Re-submittal Form

RCU2022-00016

RESUBMITTAL CONTENTS

VIP PARKING
 23905 EAST 26TH AVENUE
 AURORA, CO

PHASE I & II LANDSCAPING

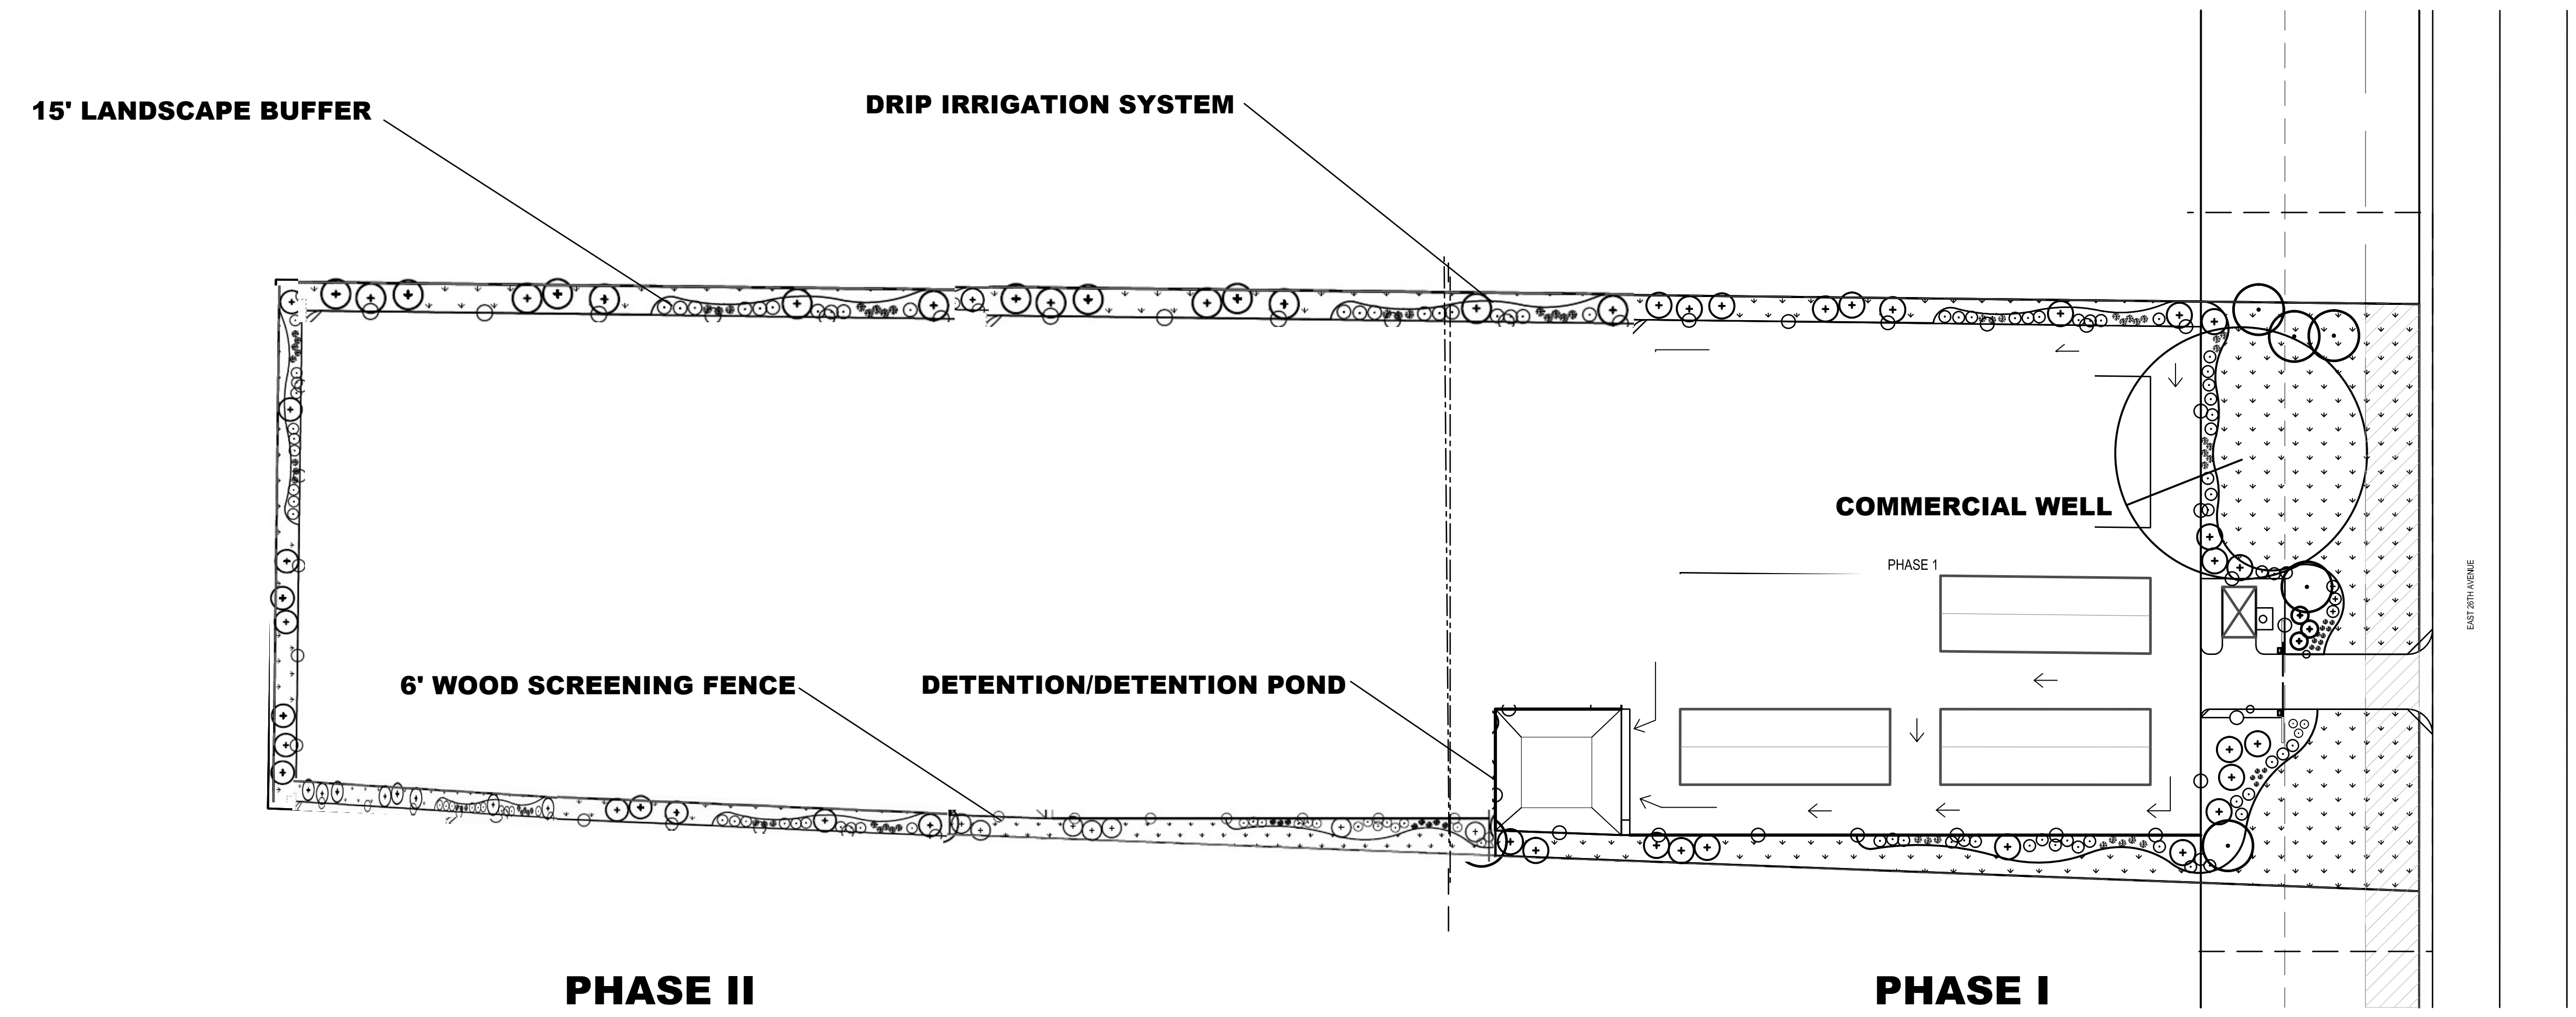
PLN01: Landscaping - need a detailed landscaping plan. Please provide a landscaping plan for the whole parcel, including what was approved in Phase I.

BOTH WERE COMPLETED DURING INTIAL BOCC APPROVAL

SITE PLAN

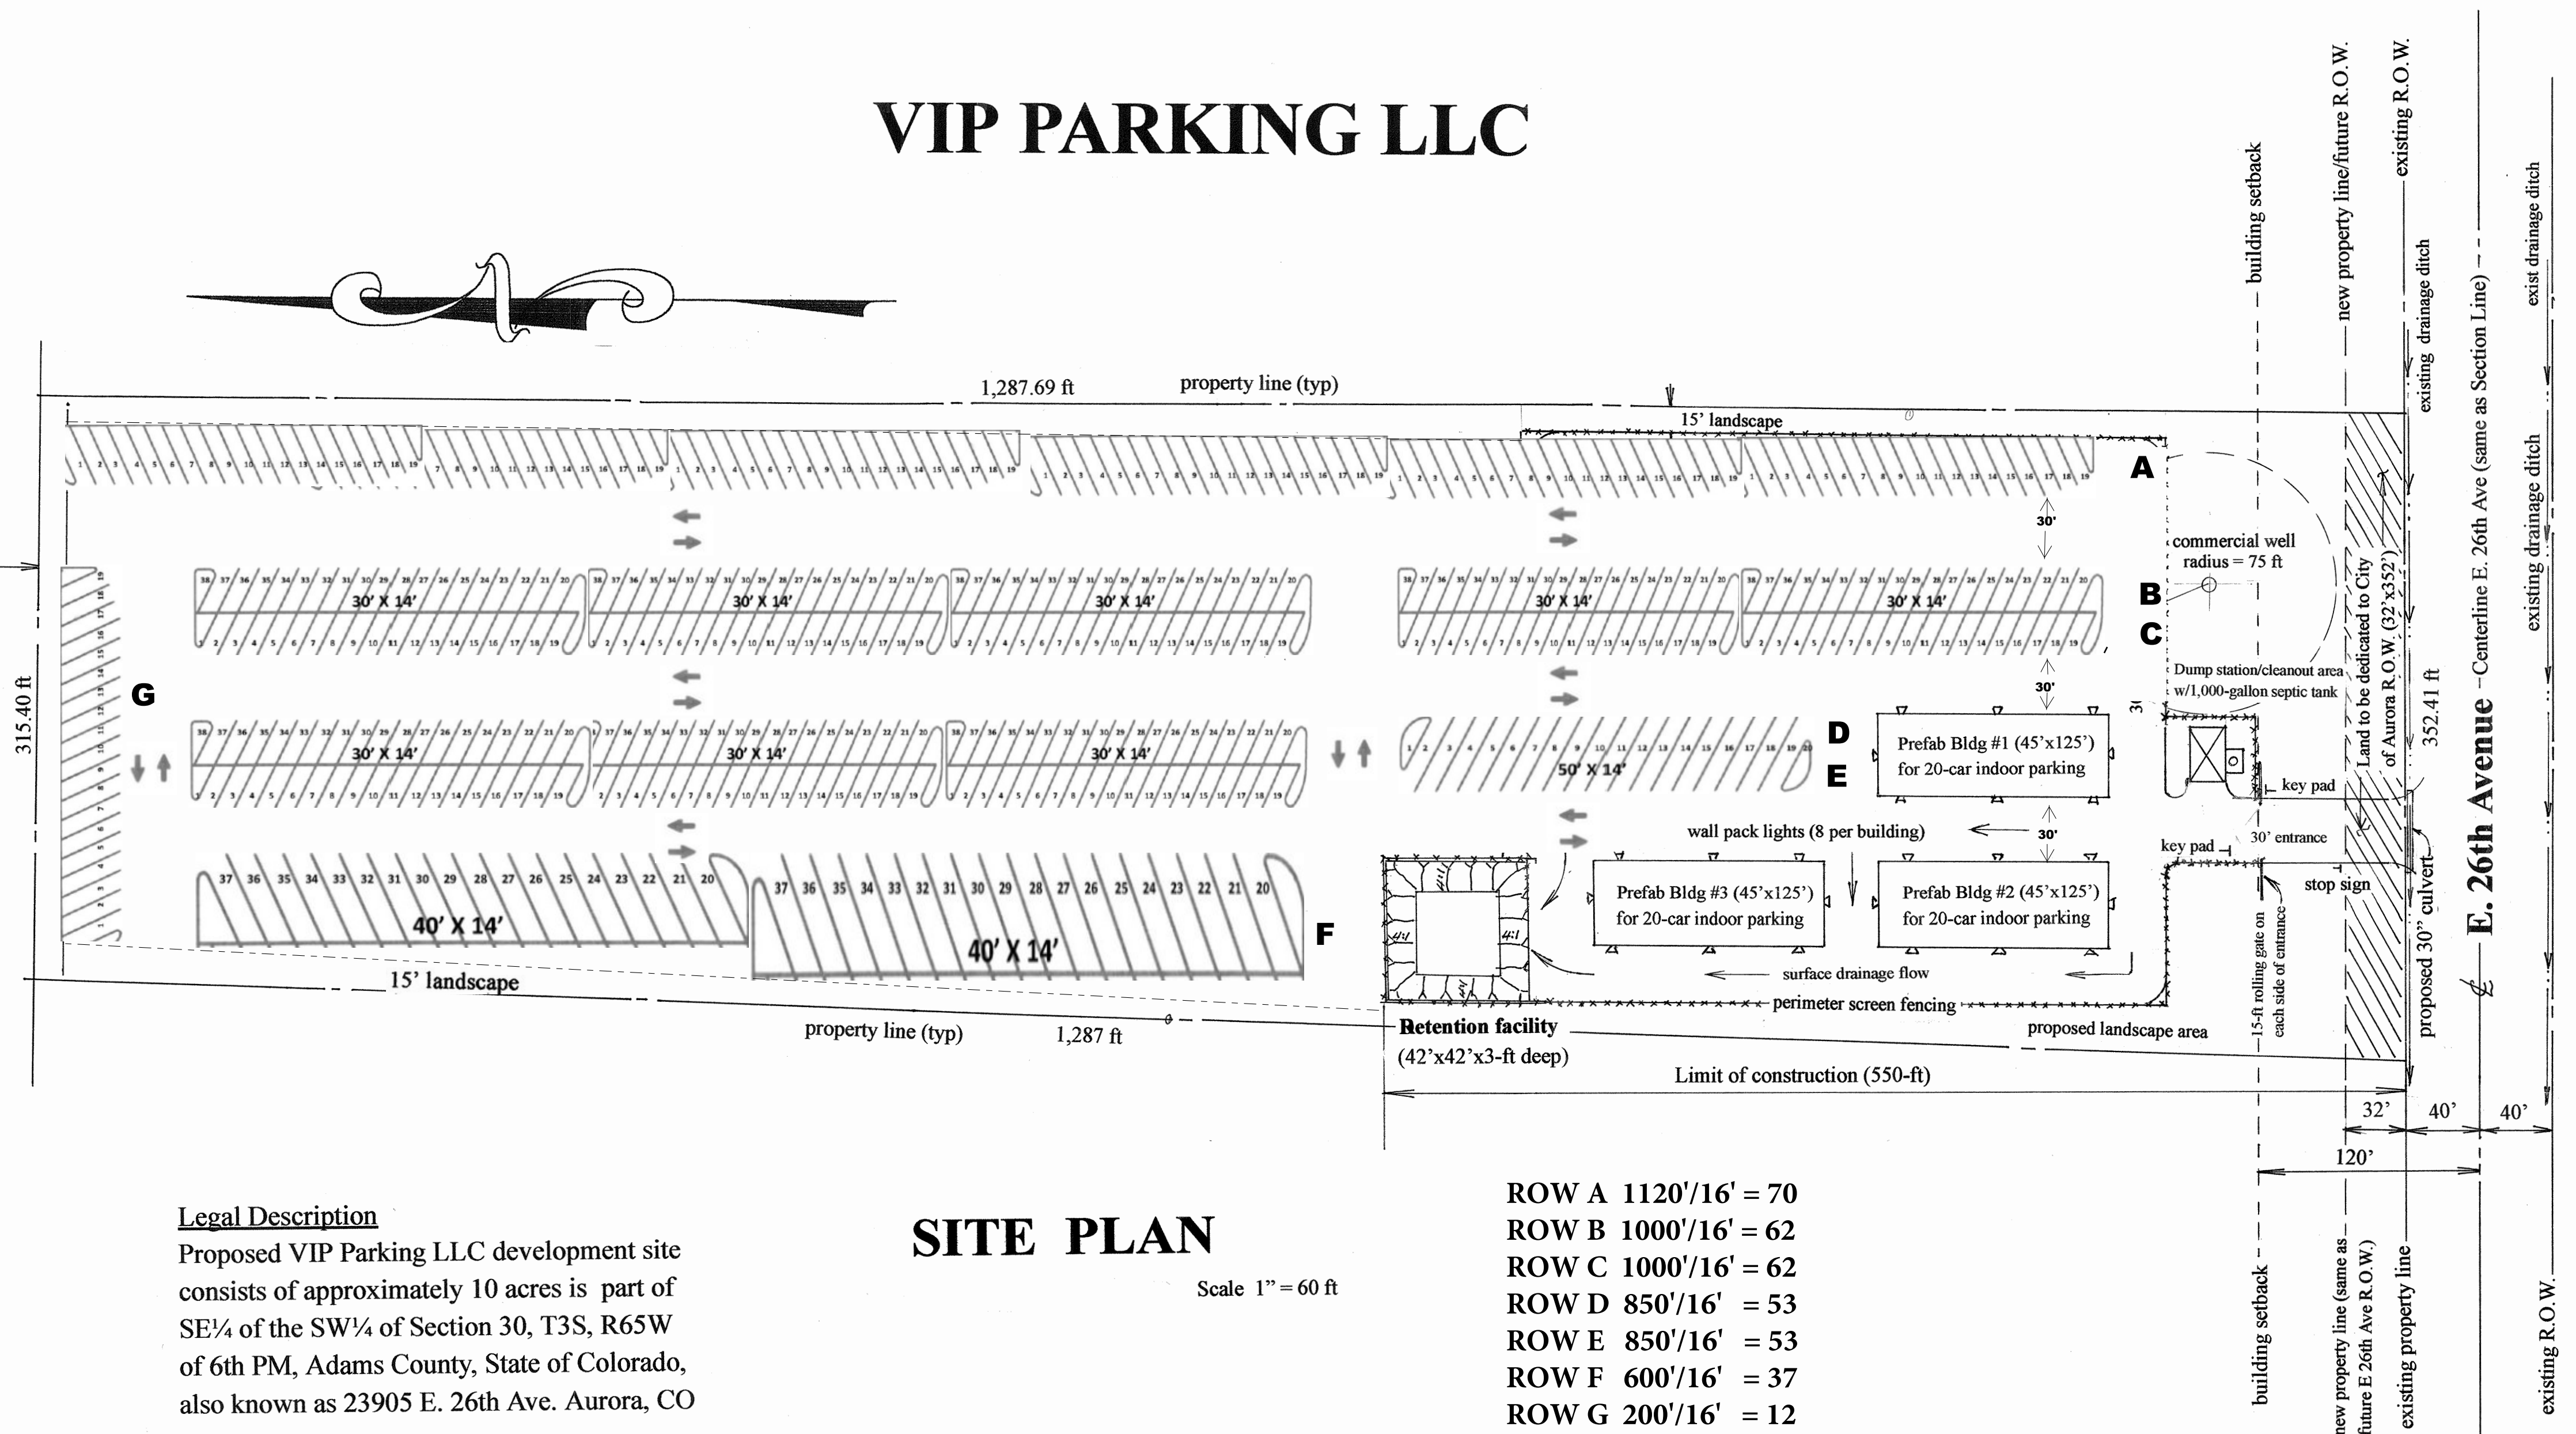
PLN 04: Site Plan - need to see well and septic system. Is there trash?

The dump station holding tank will be located just east of the driveway on the south end of the property. There is a commercial well, over 50' from the proposed holding tank. A restroom is installed with a men's and women's restroom. There will be a total of two toilets, two sinks and two drinking fountains.

The RV holding tank is a 2500 gallon monolithic concrete water tight tank, manufactured by Front Range Precast, in Boulder. The 2500-gallon size will minimize the frequency of pumping. However, frequency of pumping depends on the usage by customers and will be determined by the high-water alarm system described below.

A high-water alarm system to audibly and visually signal when the holding tank is 75% full is installed to warn that pumping the tank should be done.

Trash dumpster is located next to next to the RV dump station.

OWTS Record Drawing

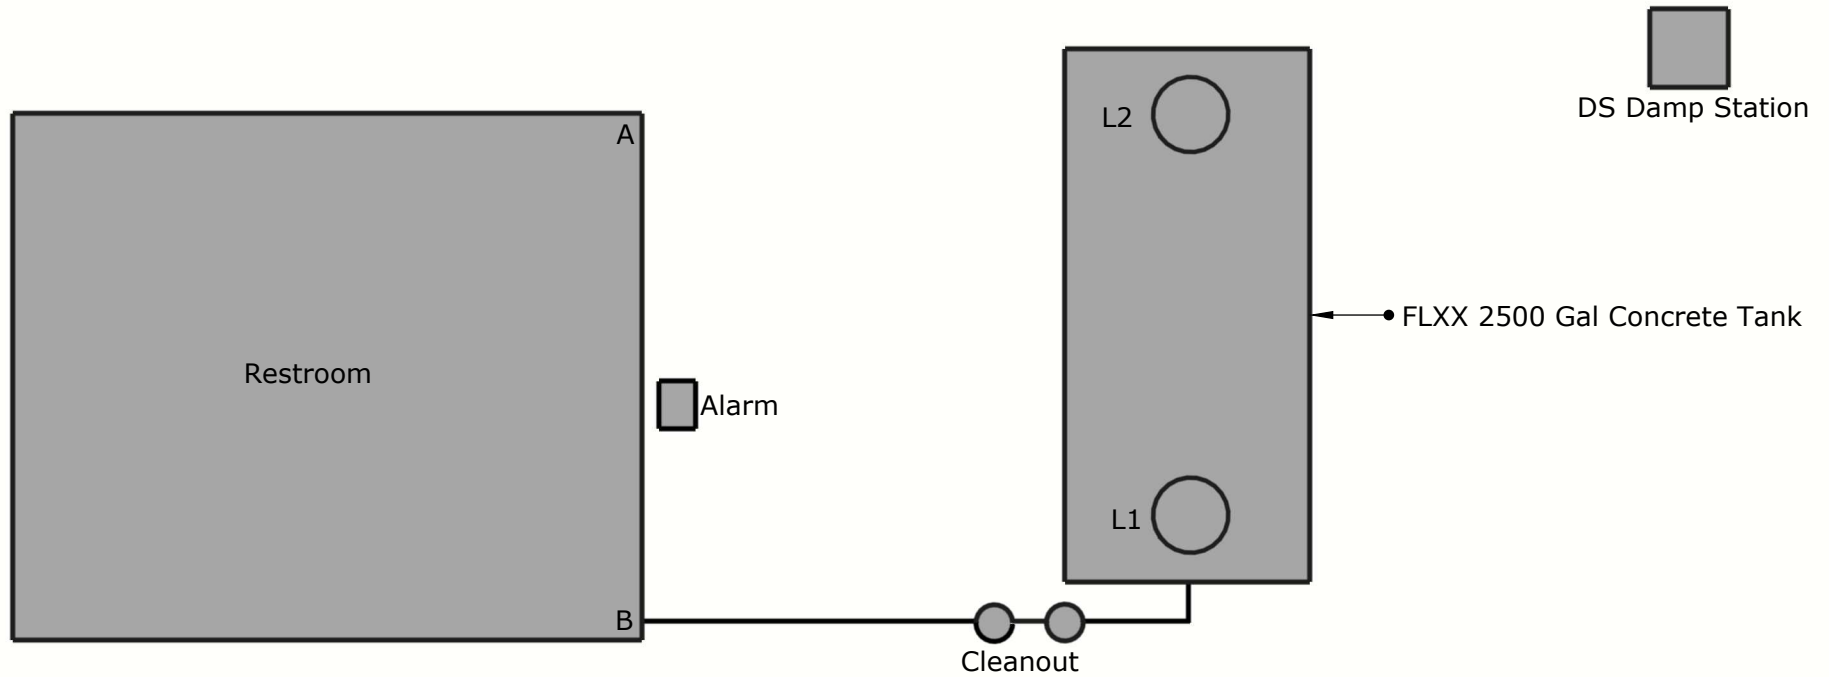
ROW2: Need to show location of septic system and limits of leach field on Site Plan.

Please refer to Parking Lot/ Site Plan of this re-submittal for location of septic holding tank. There is no leach field.

Drainage Plan - Information based on USGS TOPO Map

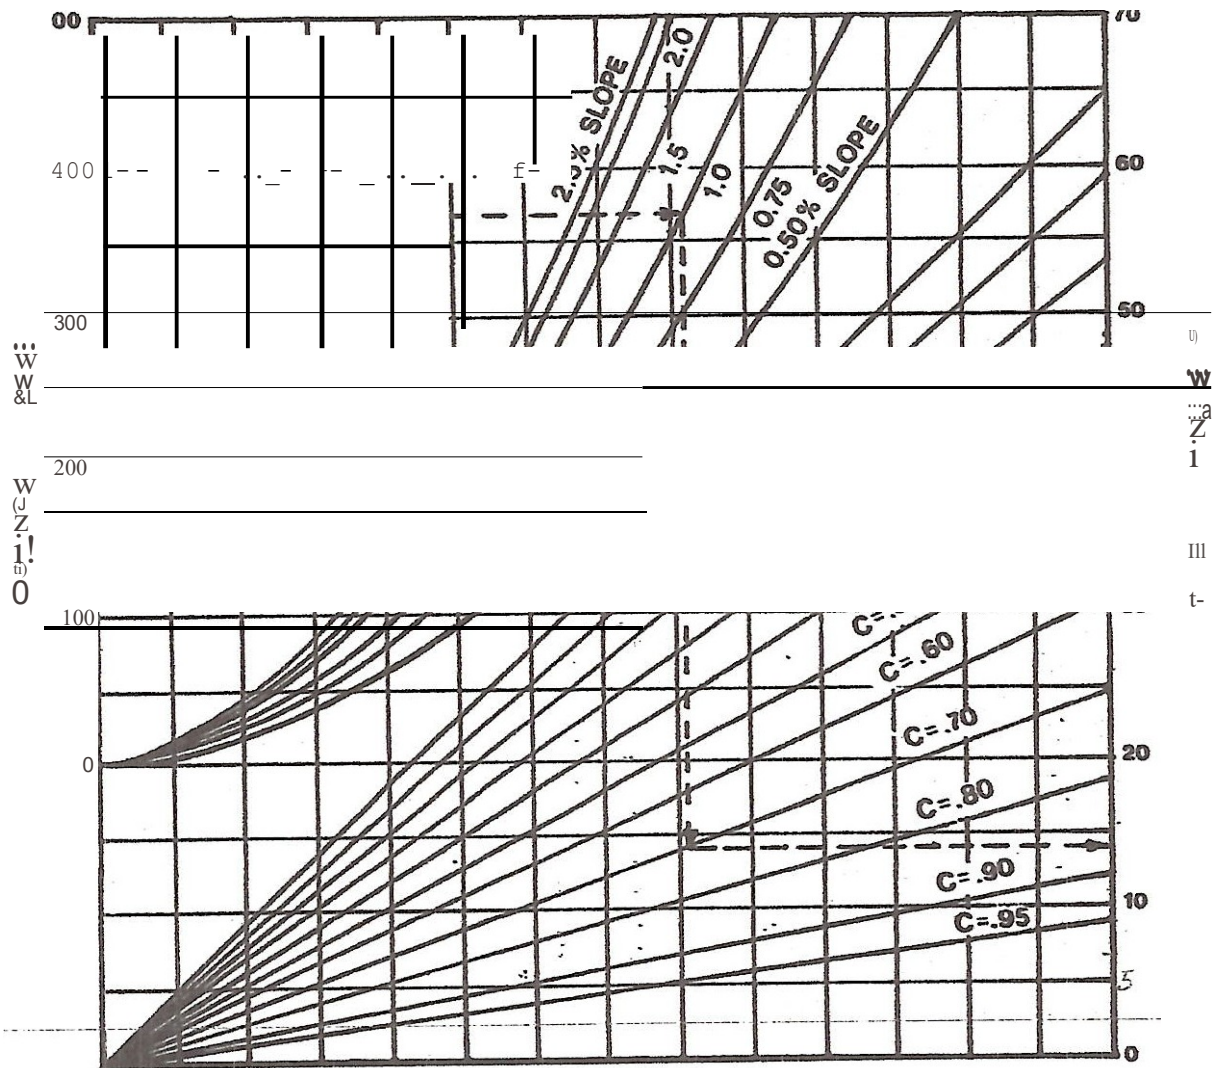
ENG6: The applicant is proposing to install over 3,000 square feet of impervious area on the project site, thus a Drainage Report and Drainage Plans prepared in accordance with Chapter 9 of the Adams County Development Review Manual, would be required to be completed by a Professional Engineer (P.E.)

Please refer to attached drainage report.
